AIRWORTHINESS DIRECTIVE

McDonnell Douglas (Hughes) and Kawasaki 369 Series Helicopters**AD/HU 369/109****Tail Rotor Gearbox Attachment****10/2002**

Applicability: MD Helicopters Inc. Model 369D, 369E, 369F, and 369FF helicopters, modified in accordance with Aerometals Supplemental Type Certificate (STC) SH5055NM or SH4801NM.

Figure 1 – Inspection Location

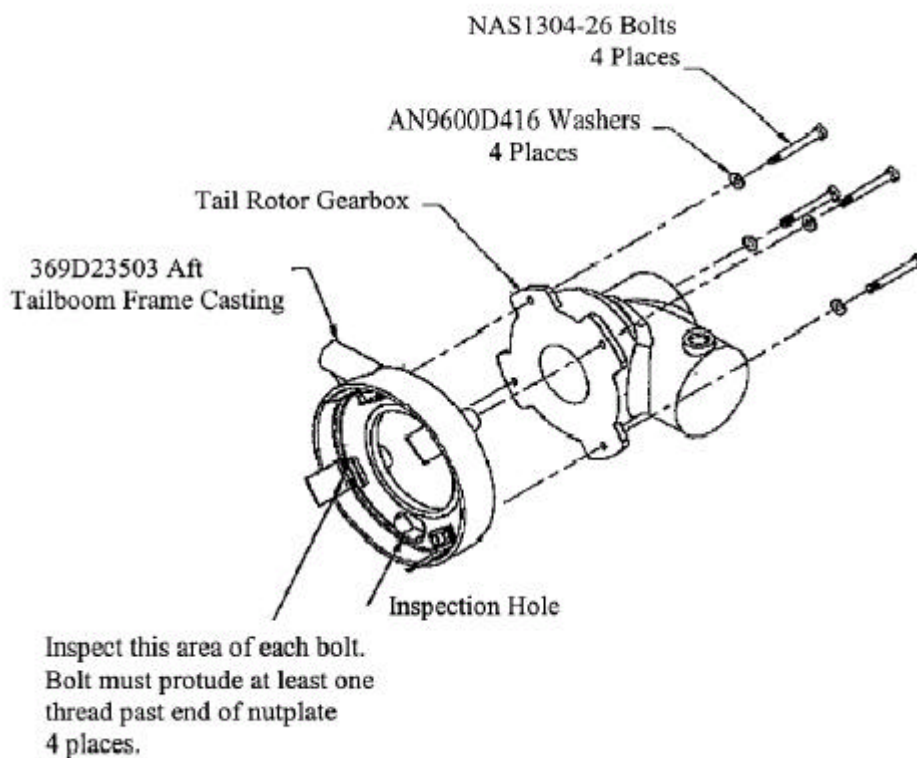
- d. Remove the tailboom control rod and determine the number of threads protruding from each nutplate on the internal surface of the aft tailboom frame casing, P/N 369D23503, as shown in Figure 1 of this Directive. At least one thread must protrude. If more than four threads protrude, add an additional washer, P/N AN960D416, under the bolt head.

Background: The bolts that attach the tail rotor gearbox have been found to be of inadequate grip length. This Directive introduces an inspection and possible replacement of the bolts to ensure the integrity of the gearbox for safe operation of the helicopter.

- b. If the part number cannot be determined or if the bolt is not P/N NAS1304-26, replace the bolt with bolt, P/N NAS1304-26.
 - c. Torque the bolt to 100-110 in-lbs and apply slippage mark.

- e. Torque the bolt to 100-110 in-lbs and re apply slippage mark.
 - 2. Repetitive Inspection:**
 - a. Re check the attachment bolts for correct torque and re-torque if necessary.
